Current Zoning: MUDD-O (mixed use development, optional) and UR-2(CD) (urban residential, conditional)  
Proposed Zoning: UR-2(CD) SPA (urban residential, conditional, site plan amendment)

Approximately 4.48 acres located on the west side of Yuma Street, east of West Sugar Creek Road, and south of Interstate 85.

The petition proposes to amend a previously approved rezoning 2018-154 to allow up to 52 multi-family residential dwelling units with a density of 11.6 dwelling units per acre.

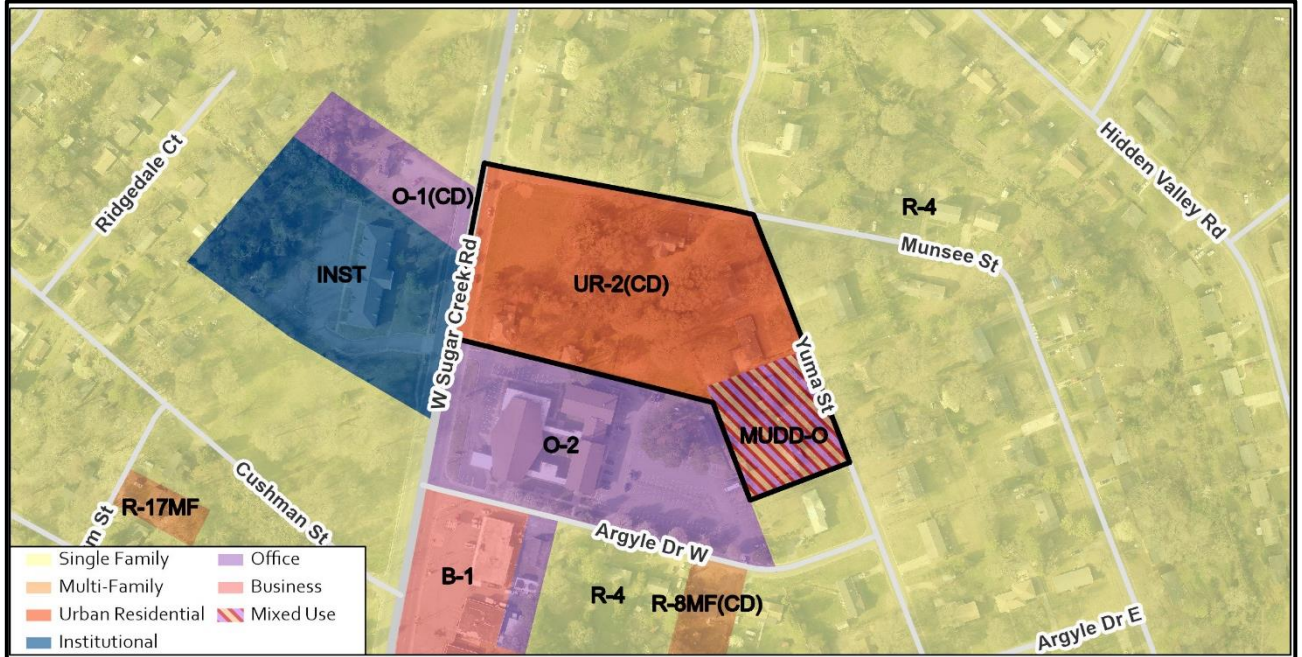
1. Label and dimension the curb and gutter from the centerline for each road on the site plan.
2. Munsee Street: Revise the back of curb label "To be replaced with CLDSM 10.17A Standard 2'-6" Curb and Gutter"

3. Yuma Street: Revise the back of curb label "To be replaced with CLDSM 10.17A Standard 2'-6" Curb and Gutter"
4. 8-foot sidewalk required on all frontages. Revise the site plan to incorporate the 8-foot sidewalk on Yuma Street and Munsee Street. The wider sidewalk also meets the Charlotte WALKS Policy.

5. Site plan and conditional note(s) revisions are needed to revise conditional note (Section 4.a.) to provide a recorded access easement with the owner of PID (08904203).

6. Revise note 4.a to read "Access to the site will be from Munsee Street and Yuma Street. Pending acquisition of a cross-access easement from Mayfield Memorial Baptist Church (PID 08904203), additional access may be provided in the form of an internal driveway connection"

7. Add note that petitioner will comply with the City of Charlotte Tree Ordinance. The required 15% tree save must be preserved on site. Show on site plan with widths.
